FINAL PRODUCT/PROCESS CHANGE NOTIFICATION #16504

Issue Date: 30-Jul-2010

TITLE: Qualification of Serial SPI EEPROM devices CAT25080, CAT25160 and CAT25640 for fabrication at ON Semiconductor's Gresham, Oregon Wafer Fab

1) SOIC -150mil 8pin (W, V), SOIC – 208mil 8pin (X)

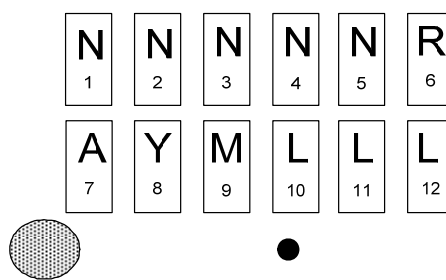
Current OKI die

FRONT SIDE MARK:

- 1: Assembly location code
- 2: Mark "4" for (lead finish NiPdAu)
- 3: Product Revision
- 4-9: Product Name: "PPPPPP"
- 10: Temp Range (I=Industrial; E=Extended)
- 11: Production Year (last digit)
- 12: Production Month (1-9, A,B,C)
- 13-16: Last four digits of assembly lot number

New Gresham die

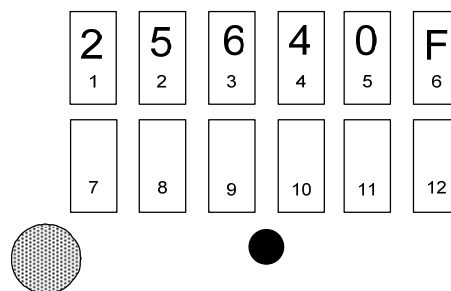
FRONT SIDE MARK:

- 1-5: Device name(5 char)
- 6: Production Revision
- 7: Assembly location
- 8: Production Year
- 9: Production Month
- 10-12: Assembly Lot Number

2) TSSOP- 8pin (Y)

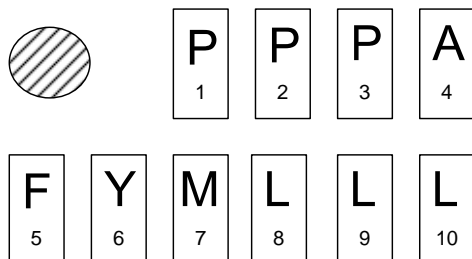
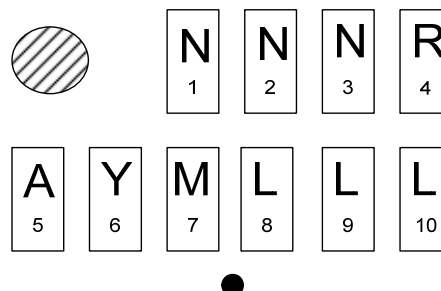
Current OKI die

New Gresham die

FRONT SIDE MARK:

- 1-3: Device name "PPP"
- 4: Assembly location
- 5: Lead finish
- 6: Production Year
- 7: Production Month
- 8-10: Assembly Lot Number

FRONT SIDE MARK:

- 1-3: Device name (3 digit)
- 4: Product Revision
- 5: Assembly location
- 6: Production Year
- 7: Production Month
- 8-10: Lot Number

3) TDFN 2x3mm (VP2) and UDFN 2x3mm (HU3, HU4)

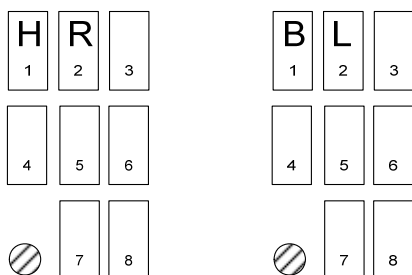
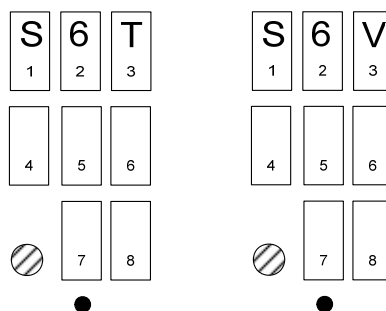
Current OKI die

FRONT SIDE MARK:

- 1-2: Device name
- 3: Assembly location
- 4-6: Lot Number
- 7: Production Year
- 8: Production Month

New Gresham die

FRONT SIDE MARK:

- 1-2: Device code
- 3: Code for revision and package
- 4: Assembly location
- 5-6: Lot Number
- 7: Production Year
- 8: Production Month

4) PDIP 8LD (L)

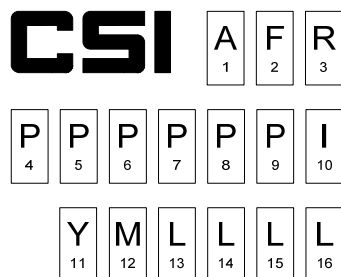
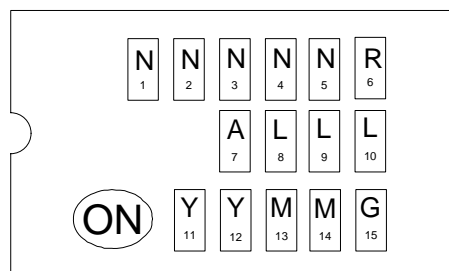
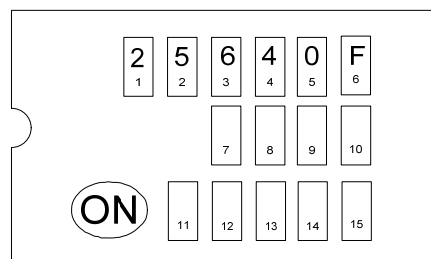
Current OKI die

FRONT SIDE MARK:

- 1: Assembly location code
- 2: Mark "4" for (lead finish NiPdAu)
- 3: Product Revision
- 4-9: Product Name: "PPPPPP"
- 10: Temp Range (I=Industrial; E=Extended)
- 11: Production Year (last digit)
- 12: Production Month (1-9, A,B,C)
- 13-16: Last four digits of assembly lot number

New Gresham die

1-5: Device name

6: Product Revision

7: Assembly location code

8-10: Assembly lot number

11-12: Production Year

13-14: Production Week

15: Pb-free designator
